DART AEROSPACE LTD		Work Order:	99871
Description: Crosstube High Aft (205/212)		Part Number:	D212-664-201
Inspection Dwg: D212-664-241 Rev: D		Page 1 of 1

DRAWING NO. D212-664-241	TITLE CROSSTUBE ASSY (205/212 HI AFT)	REV. D	DART AEROSPACE LTD ENGINEERING ORDER		D.E.O. NO. D212-664-241-D-1	SHEET NO. SHEET 1 OF 2	SCALE NTS
DRAWN	CHECKED	MFG. APPR.	APPROVED	DE APPR.			
DATE 11.04.07	DATE 11.04.11	DATE 11.04.12	DATE 11/04/12	DATE 11.04.12

DRAWING NO. D212-664-241	TITLE CROSSTUBE ASS'Y (205/212 HI AFT)	REV. D	DART AEROSPACE LTD ENGINEERING ORDER		D.E.O. NO. D212-664-241-D-2	SHEET NO. SHEET 1 OF 1	SCALE NTS
DRAWN 92	CHECKED ASS	MFG. APPR. DS	APPROVED MD		DE APPR. TH		
DATE 11.07.15	DATE 11.07.20	DATE 11.07.21	DATE 11/07/21		DATE 11.07.21

DART SERVICE INSTRUCTION

**D212-664-241/-241B
ASSEMBLY DETAIL**

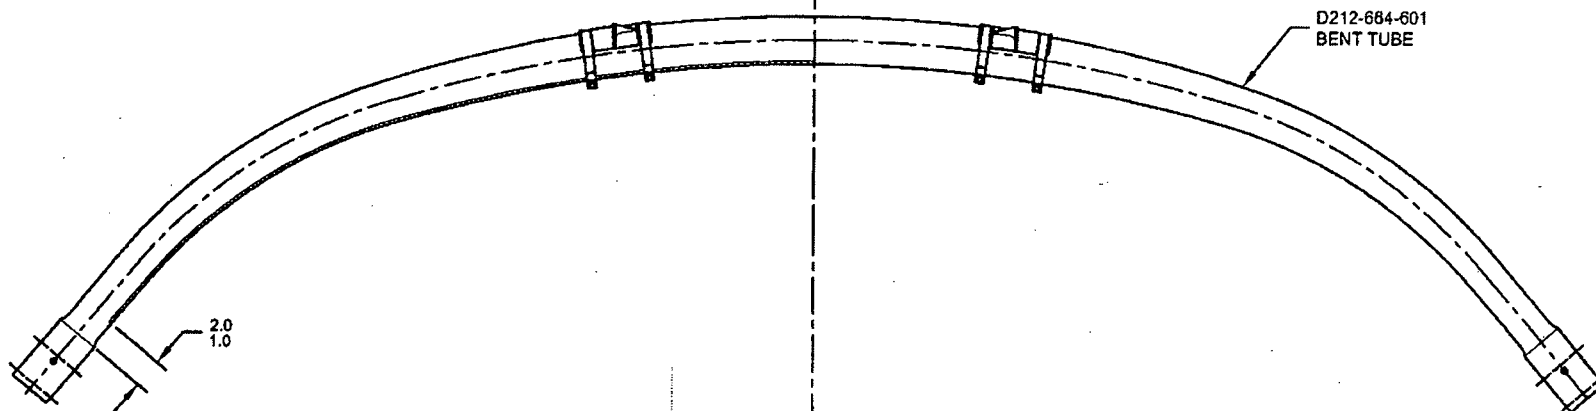
ADD AN INSPECTION WINDOW TO UNDERSIDE OF CROSSTUBE.

- 2) FINISH: CHEMICAL CONVERSION COAT PER DART QSI 005 4.1
PRIME INSIDE AND OUTSIDE PER DART QSI 005 4.2
MASK UNDERSIDE OF CROSSTUBE AS SHOWN (HATCHED AREA) AND
PAINT OUTSIDE PER DART QSI 005 4.2
REMOVE MASKING AND APPLY CLEAR COAT

- 2) FINISH: CHEMICAL CONVERSION COAT PER DART QSI 005 4.1
PRIME INSIDE AND OUTSIDE PER DART QSI 005 4.2
PAINT OUTSIDE PER DART QSI 005 4.2

MASK AREA PRIOR TO PAINTING,
REMOVE MASKING AFTER PAINT
AND APPLY CLEAR COAT

FIGURE 1: SUPPORT INSTALLATION

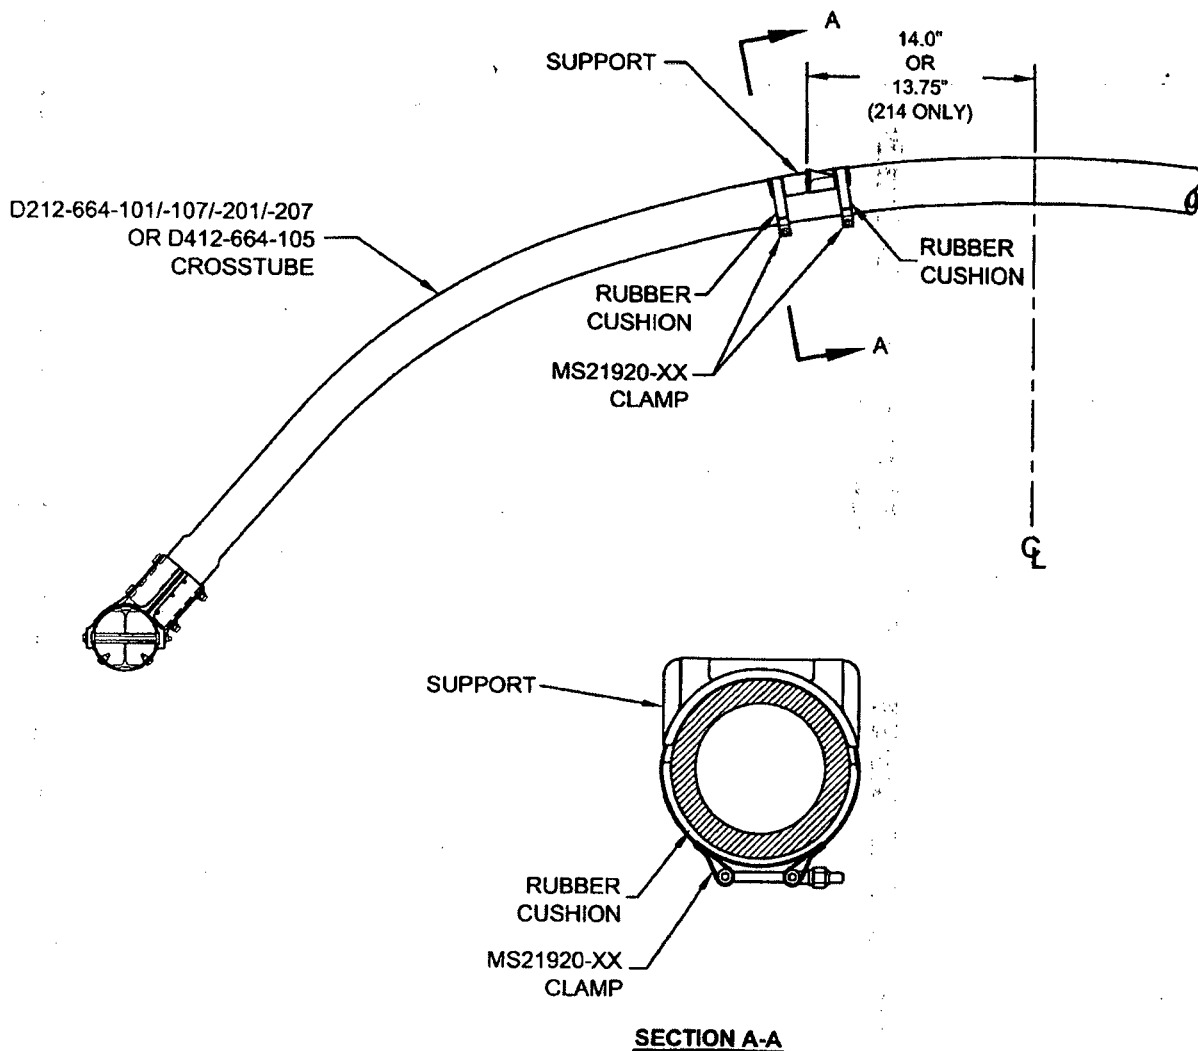
The supports on the following crosstubes are now installed using Proseal instead of Magnobond:

For the crosstubes listed above, section 32.4 of ICA-D212-664 is amended as follows. Use Figure 1 of this service instruction and Figures 32-2 to 32-9 of ICA-D212-664 for further reference. For crosstubes of an earlier change number, it is recommended that if the supports are removed, the supports should be reinstalled using the procedure listed below.

- 32.4.5 Apply a 0.04" to 0.07" thick layer of Proseal 890 Class B or AMS-S-8802 Class B sealant underneath applicable support and install support as shown in Figure 1 of this service instruction.

- 32.4.6 Install the clamps opposite to crosstube support as shown in section A-A of Figure 1. Install rubber cushions underneath each clamp around the bottom circumference of the crosstube up to the crosstube centerline. Torque clamps 80-100 in-lb (9.0-11.3 Nm). It is acceptable to use smaller or larger sized MS21920-XX clamps than those listed in ICA-D212-664, ensure that after torquing the clamps per this instruction, the nuts are in safety but not bottomed out

- 32.4.7 Prior to installing crosstube on aircraft, allow supports to cure for 72 hours and recheck torque on clamps.

CRUSHING OF D212-664-201

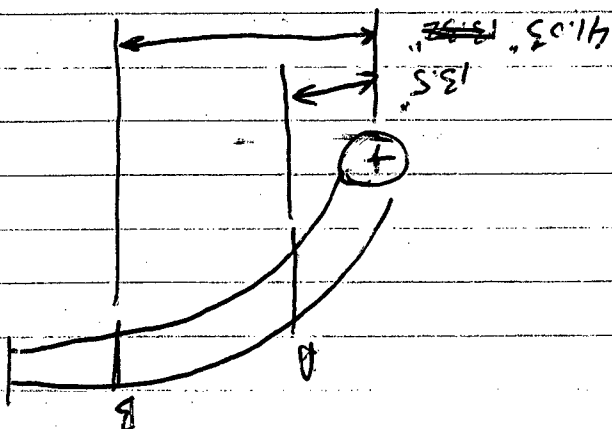
Acceptability of 8% CRUSHING

Point A: $OD = 2.548$ in. $OD = 2.492$ in.
 CRUSHING $(2.492 - 2.548) / (2.492 + 2.548) = 8\%$
 $I = 1.476$ in⁴

$MS = 14.32 / 11.65 - 1 = 0.22$
